BASE NUMBER APPROVAL
DCDC-A00405-150

ENCLOSED GROUND FLARE ASSEMBLY
 (3'-6" x 20'-0" WITH 1" - 4" TIPS)

CERTIFIED
 DRAWING NUMBER: B-F-400405-301
 SCALE: 3/4"=1'-0"

PLAN
SCALE: 1/2" = 1'-0"

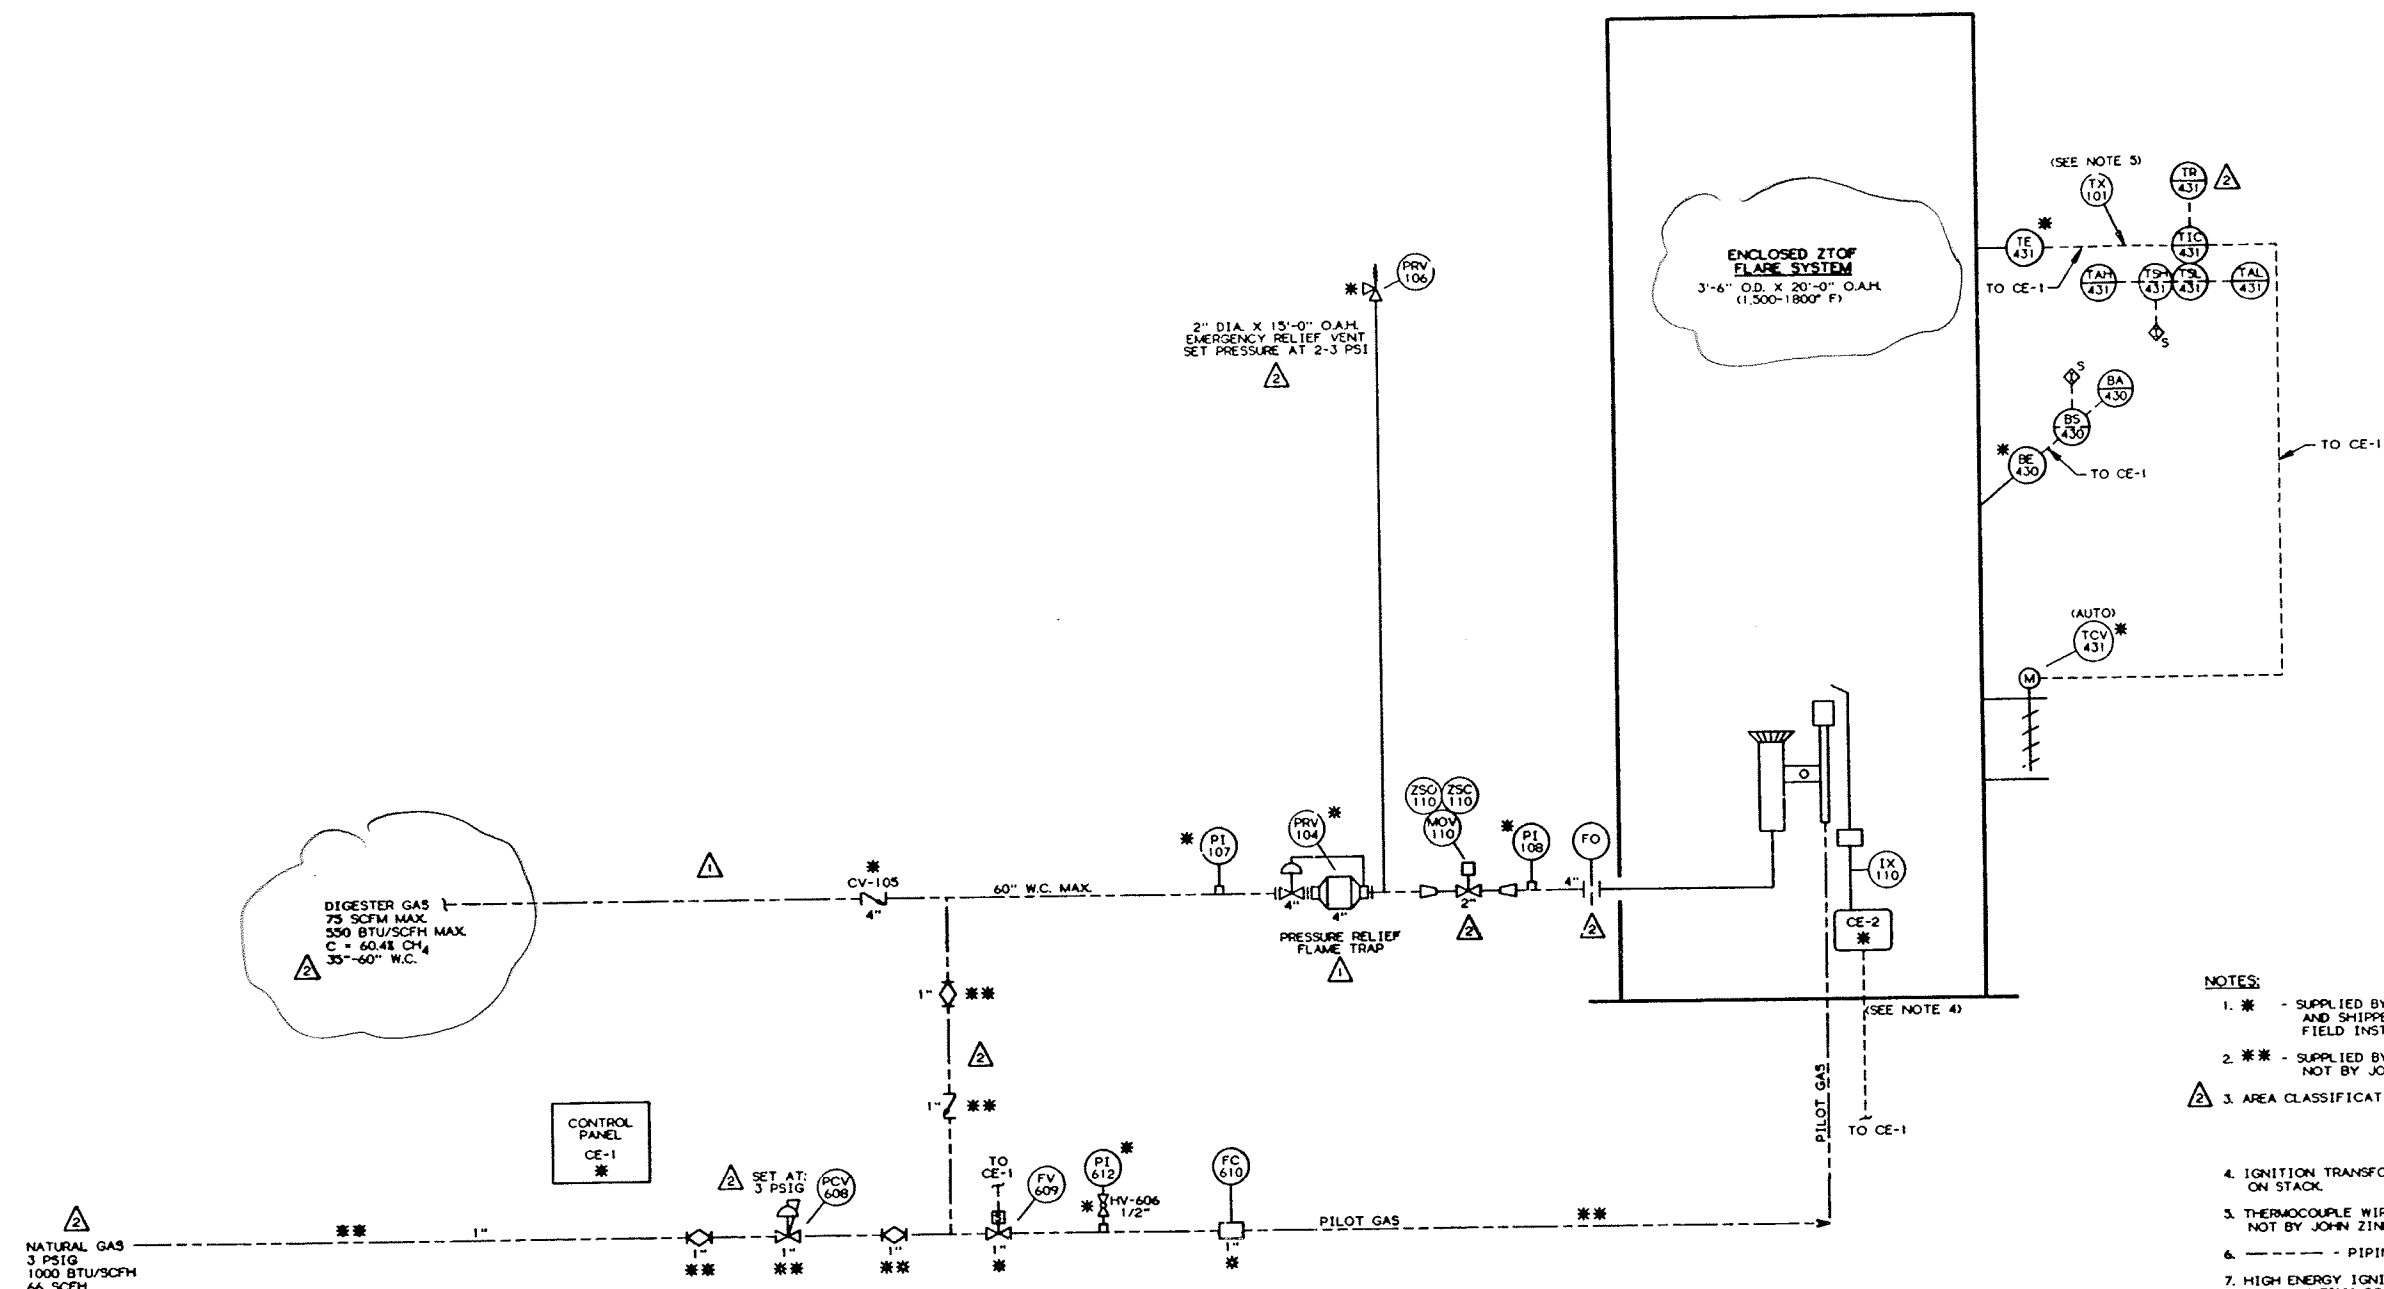
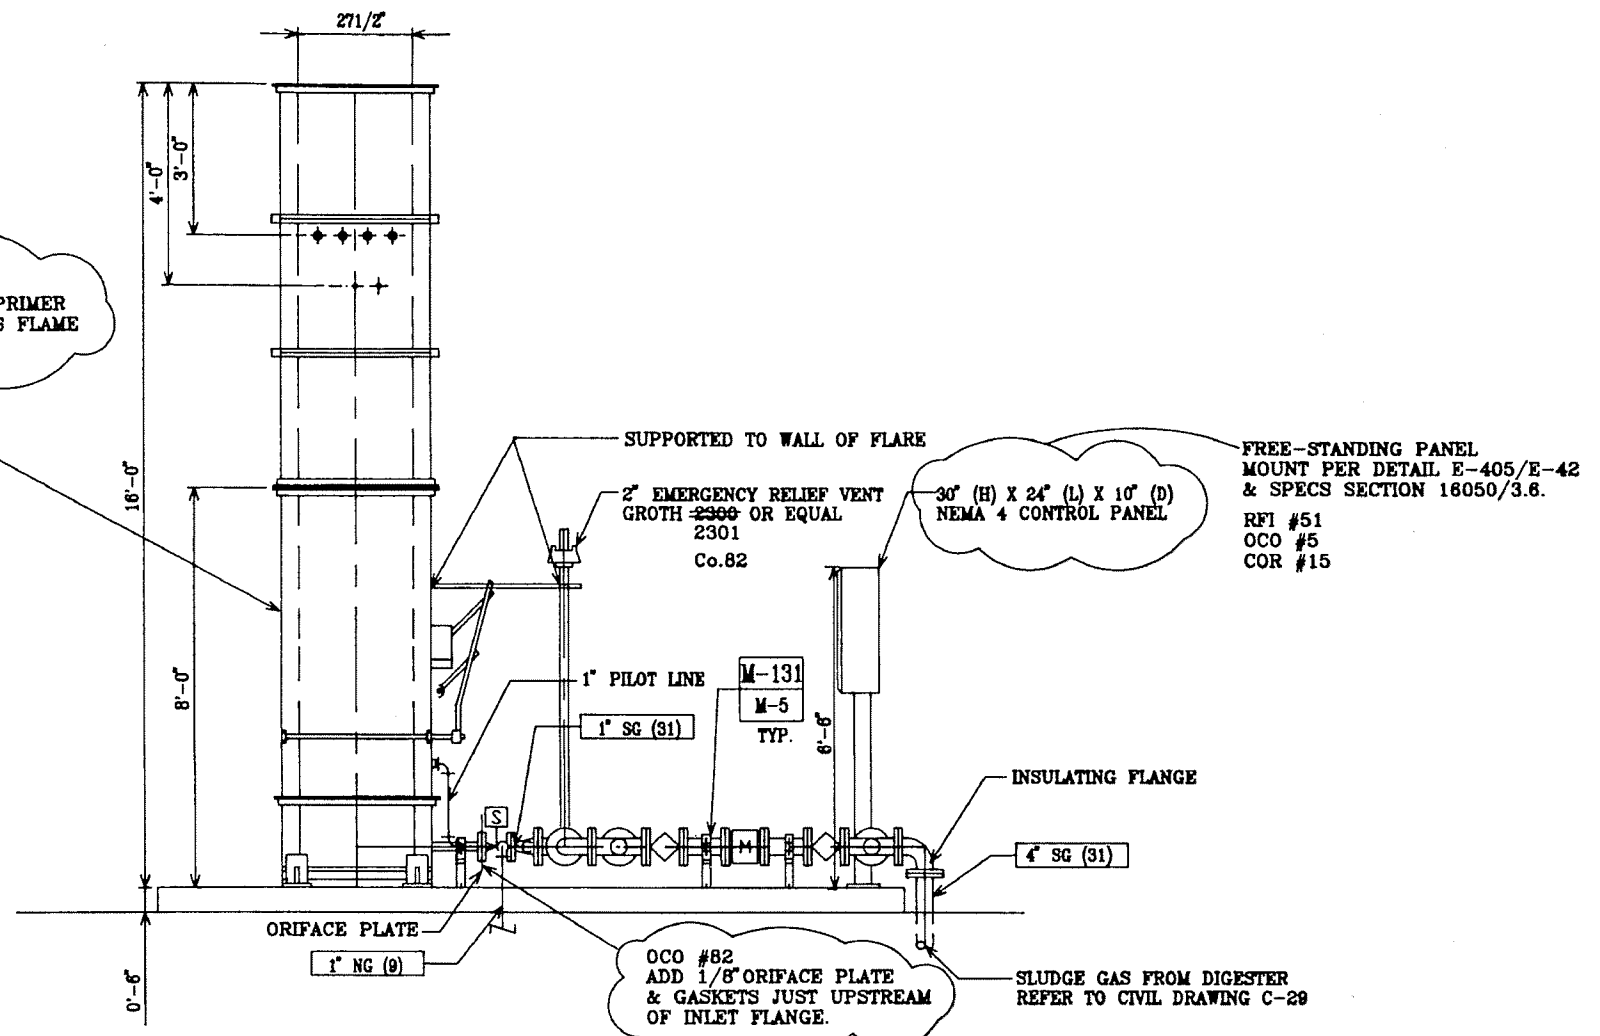
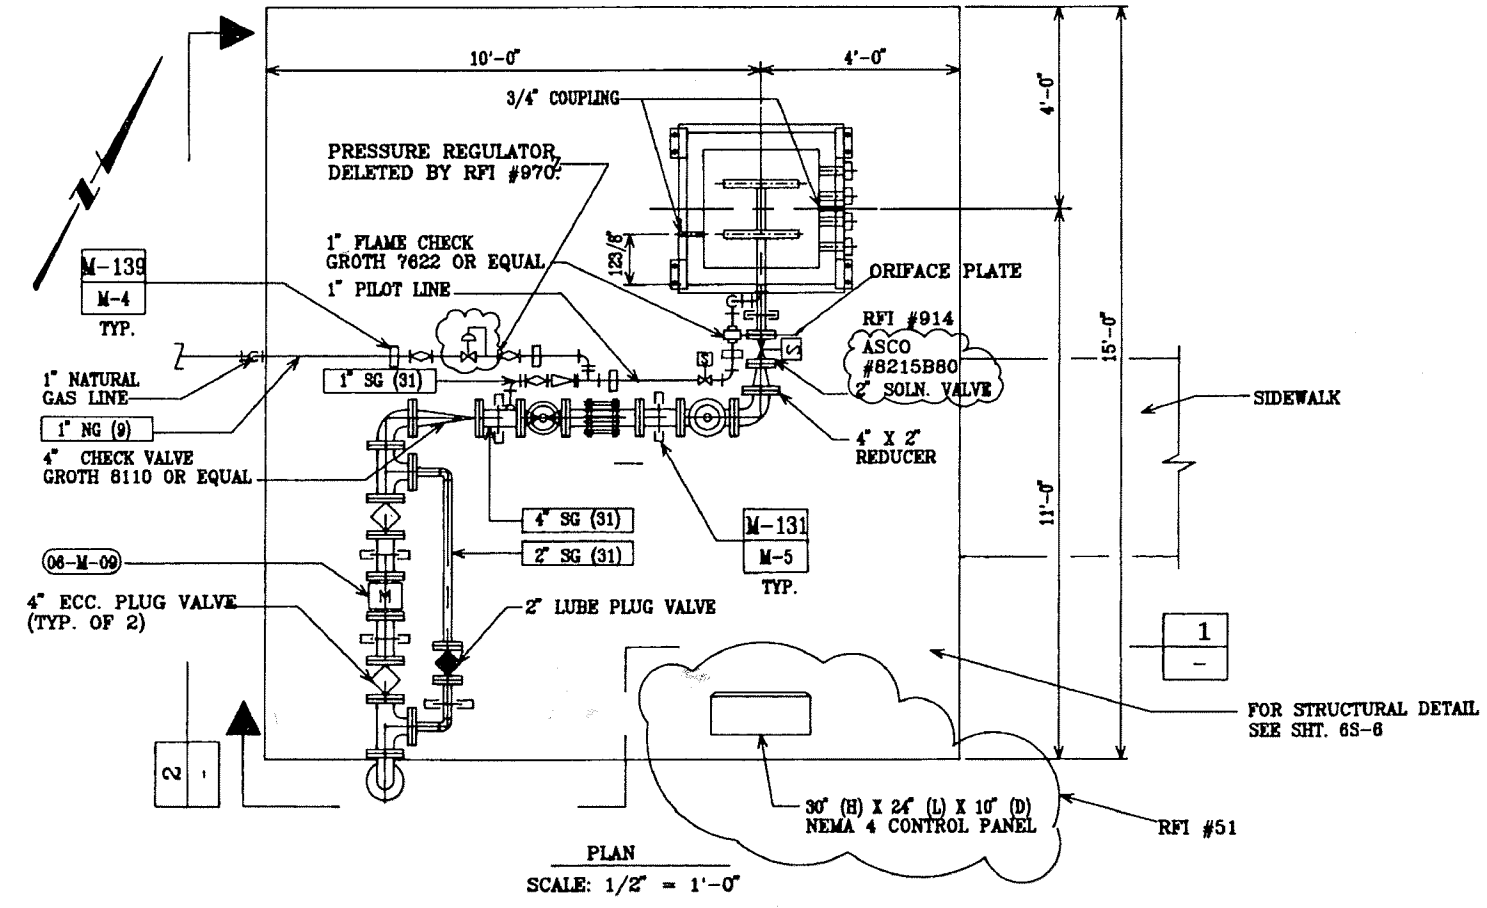
RFI #888
PAINT SYSTEM
USE 2-3 MILS INORGANIC ZINC PRIMER
W/1-1.5 MILS SHERMAN WILLIAMS FLAME
CONTROL No.500 SERIES.

FREE-STANDING PANEL
MOUNT PER DETAIL E-405/E-42
& SPECS SECTION 16050/3.6.
RFI #51
OCO #5
COR #15

OCO #82
ADD 1/8" ORIFACE PLATE
& GASKETS JUST UPSTREAM
OF INLET FLANGE.
